Staff Report

Site Plan Review - Residential Accessory Building

SP-33-18

November 21, 2018

Plot Plan

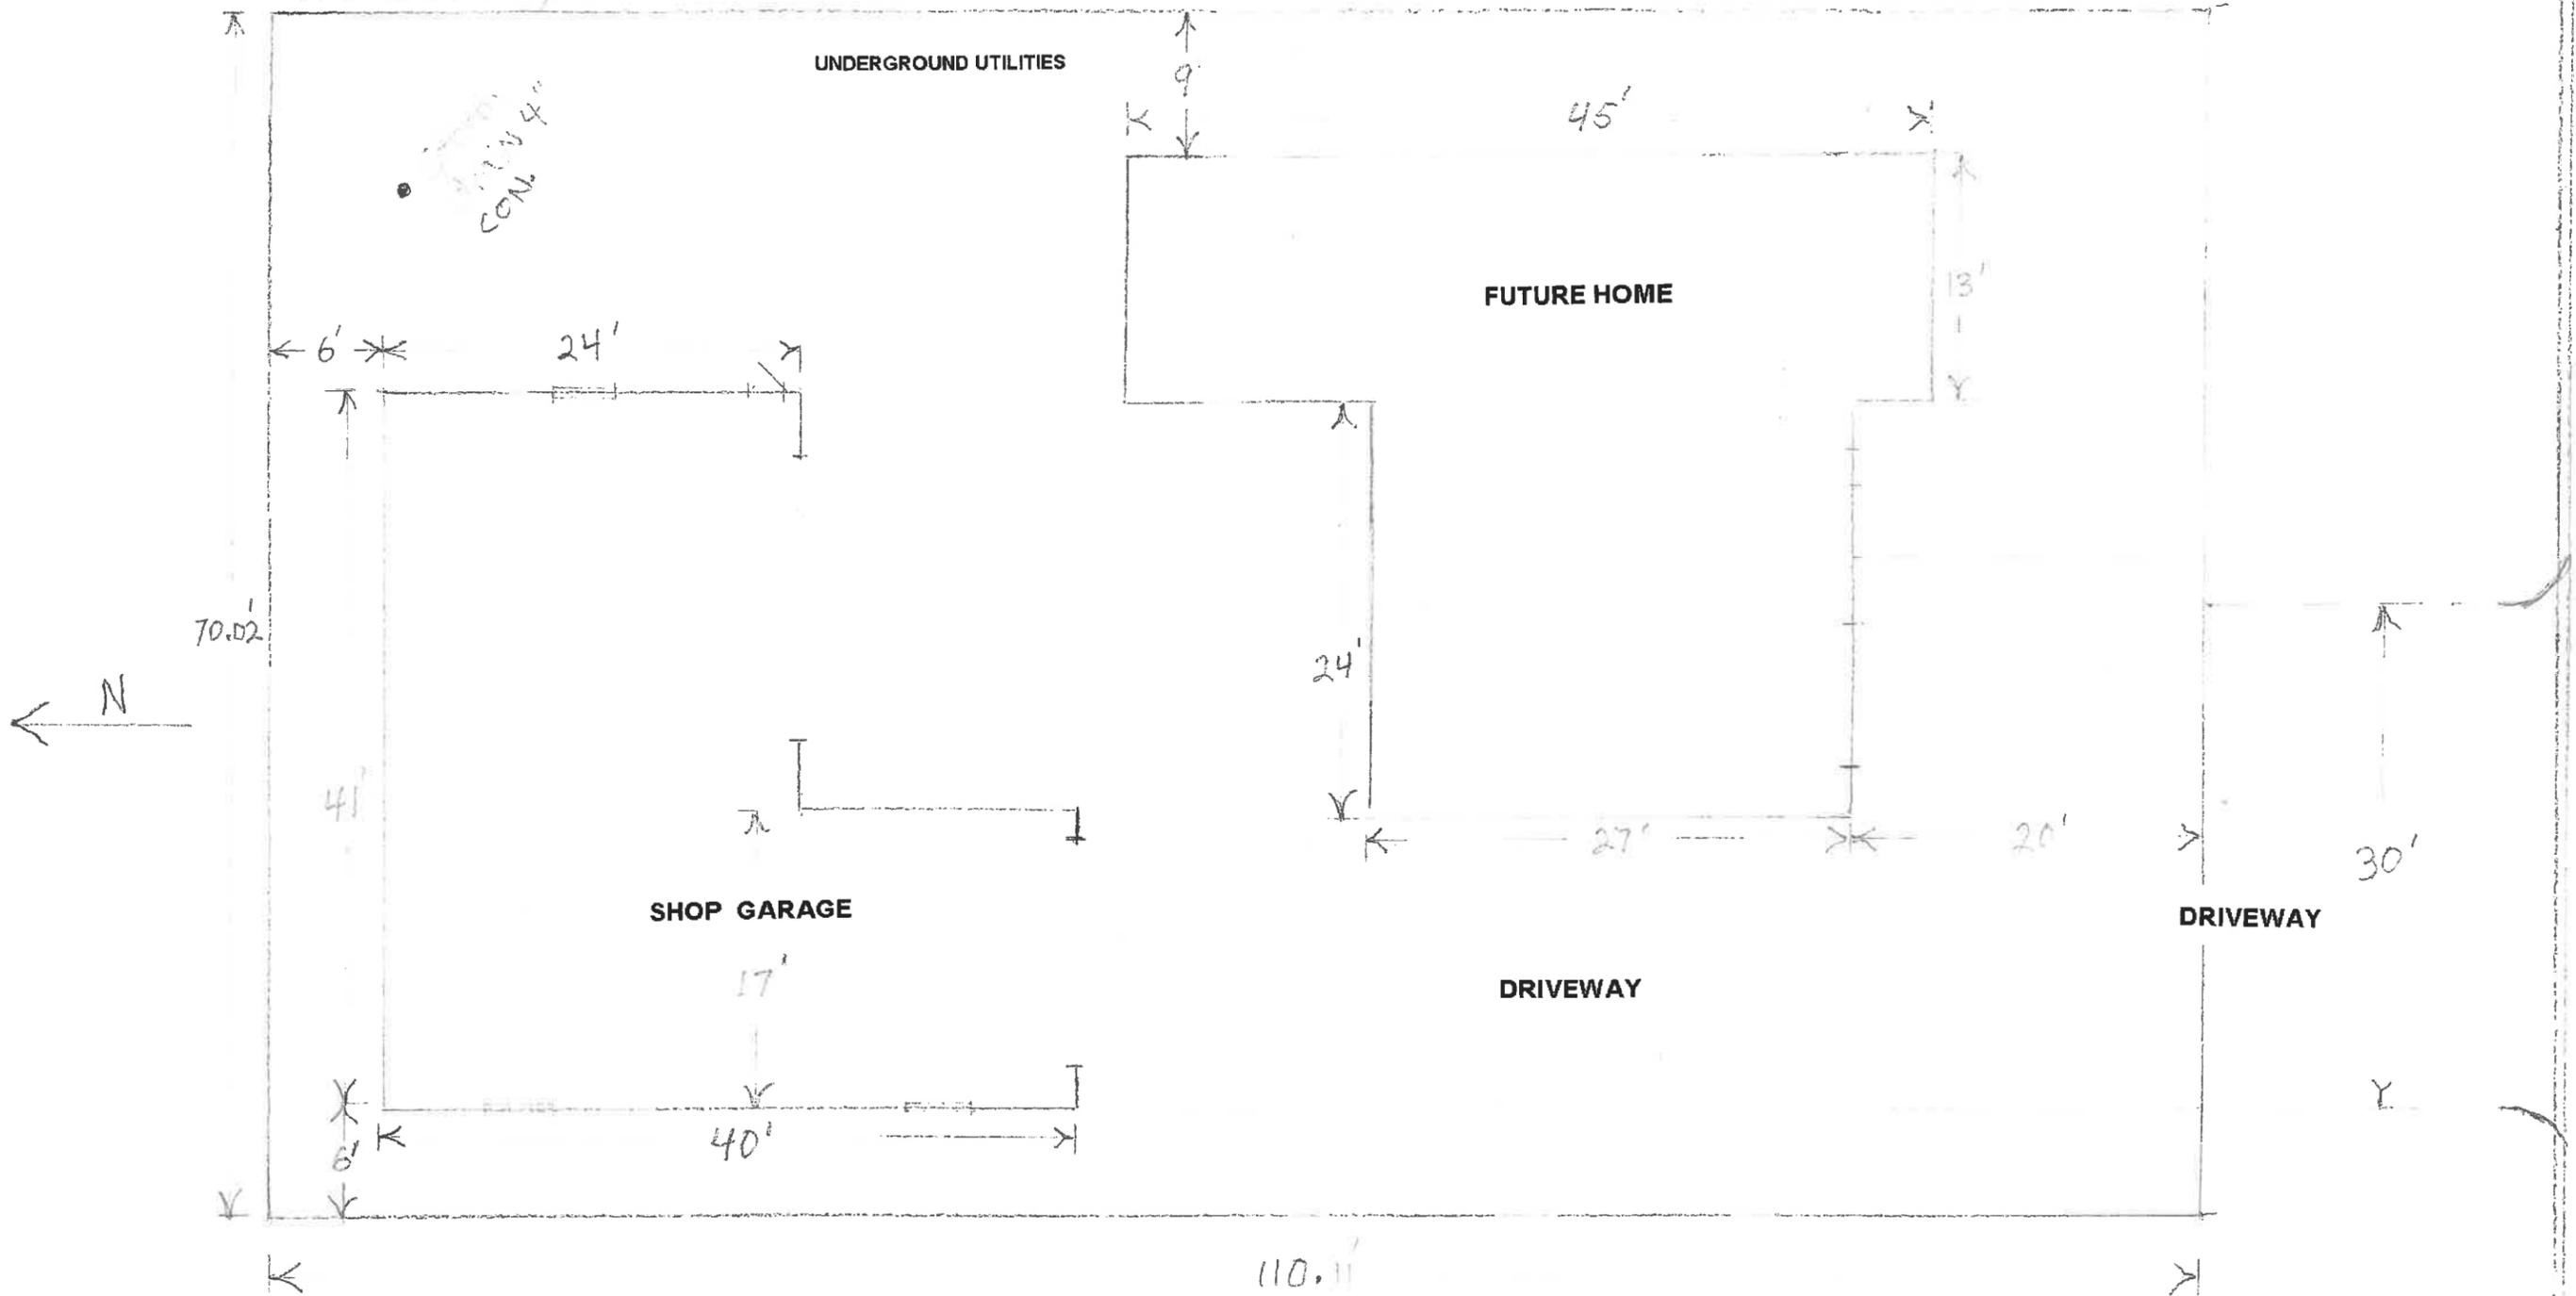
- 4.4 The applicant's site plan (Attachment C) indicates the proposed driveway will be 30 feet wide at the point of the curb cut. The proposed driveway serves both the future residence and the proposed accessory structure. The driveway narrows to approximately 17 feet once it extends behind the front of the house. Because 30 feet exceeds the maximum allowable width either the driveway must be reduced in width or the applicant must utilize separate driveways for the house and accessory structure.

A condition of approval will ensure the portion of driveway located in the public right-of-way does not exceed 24 feet in width.

- 4.5 ADC 12.100(1) requires that approaches and driveways to City streets and alleys must comply with the City's Standard Construction Specifications, which require, in part, that driveways be paved at least 20 feet as measured from the interior side of the public sidewalk. The applicant did not indicate whether the driveway will be paved. A condition of approval will require the driveway be paved for that portion extending 20 feet from the sidewalk.

- 4.7 ADC 3.250 states that "...driveways or travel aisles for residential development shall not be located in a required front or interior setback..." The subject property is located in the RS-6.5 district. The required front setback is 15 feet and the required interior setback is 5 feet. The proposed driveway is located 6 feet from the interior west property line and therefore satisfies setback requirements.

- Condition 1 Prior to the issuance of a building permit, the applicant shall submit a site plan to the Community Development Department that demonstrates the driveway width will not exceed 24 feet for that portion located in the public right-of-way.
- Condition 2 Prior to requesting final inspection, the applicant shall demonstrate that the driveway is paved 20 feet from the sidewalk.
- Condition 3 Prior to approval of a final inspection, the applicant shall obtain an encroachment permit from the Public Works Department, and construct public sidewalk along the site's frontage on 36th Avenue together with a driveway located in conformance with the approved site plan.

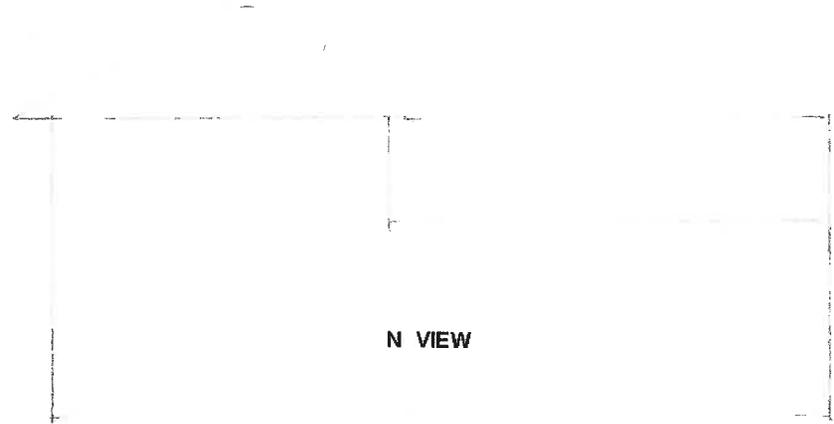
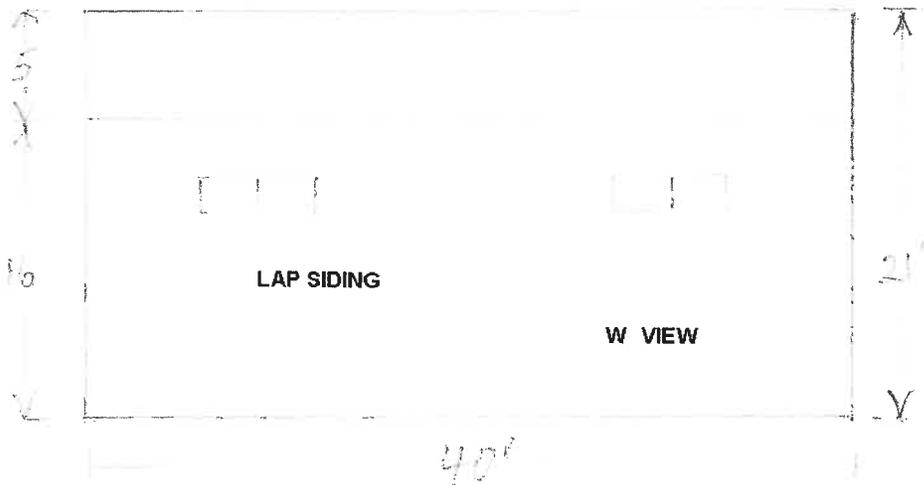
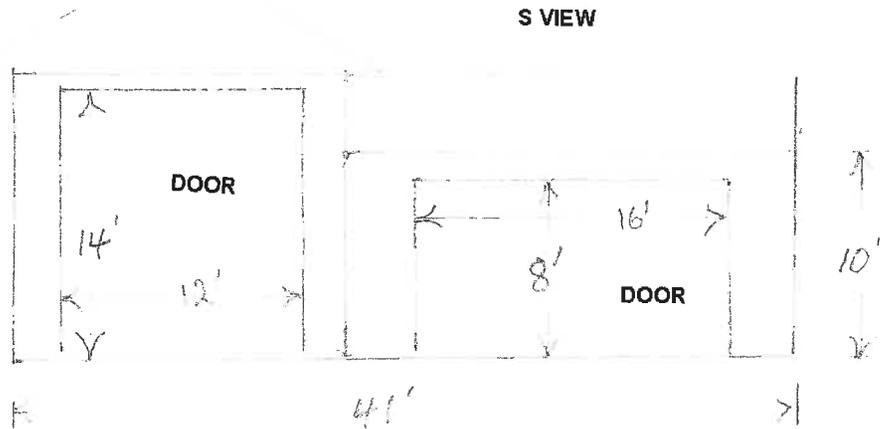
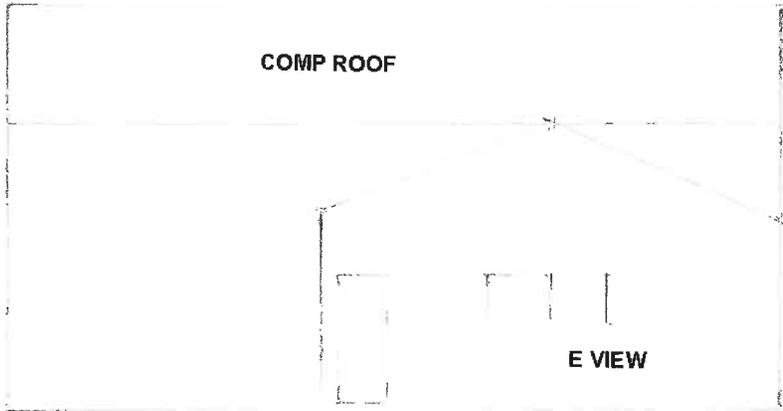
- 5.4 The proposed structure is 21 feet tall at the peak of the roof. The main portion of the structure is 41 feet long by 24 feet wide with an L-shaped extension that measures 26 feet by 17 feet, for a total of 1,256 square feet. According to the applicant's Residential Accessory Structure Compatibility Worksheet (Attachment B), the height of the tallest building on the adjacent property is 21 feet tall and is located at 2010 34th Avenue SE. The applicant also indicated that the foundation of the largest building on the adjacent property is 2,396 square feet and is located at 2041 36th Avenue SE.

- 5.5 The proposed accessory structure is both shorter than the tallest adjacent building and has a smaller foundation footprint than the largest adjacent building. Therefore, the proposed accessory structure meets these compatibility standards.
